Draft proposal

ELSA-7-03

Addendum 93: Regulation No. 94

**UNIFORM PROVISIONS CONCERNING THE APPROVAL OF VEHICLES WITH
REGARD TO THE PROTECTION OF THE OCCUPANTS IN THE EVENT OF A
FRONTAL COLLISION**

Figure 1: Measurement of V_b , V_1 , V_2

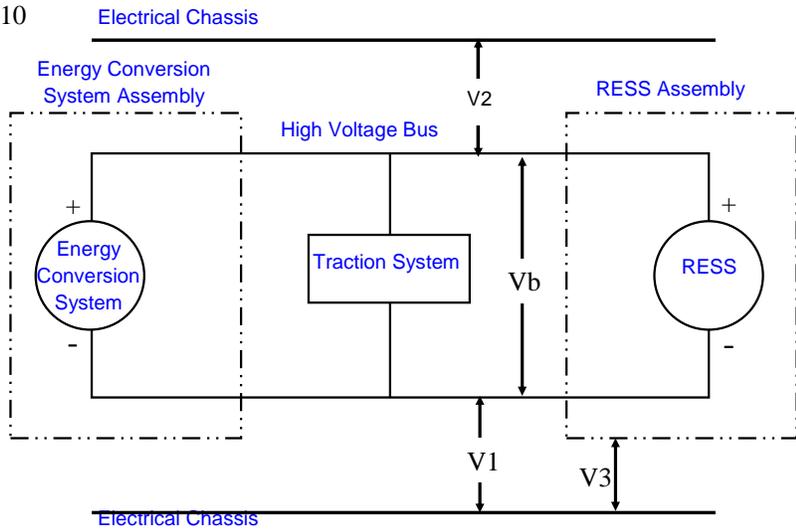
The measurement shall be made after 5 seconds (Test difficult to perform) of the vehicle coming to rest after each crash test.

V3 is not used in the text ? To discuss the test during the meeting

Figure 4: Measurement of high voltage bus energy

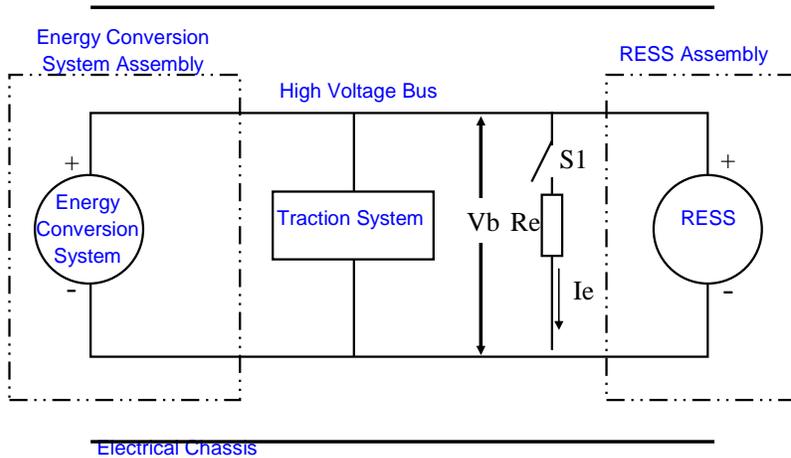
$$\int_{t_0}^{t_1} V_b \times I_e dt \quad \begin{matrix} t_0 = ??? \\ t_1 = ??? \end{matrix}$$
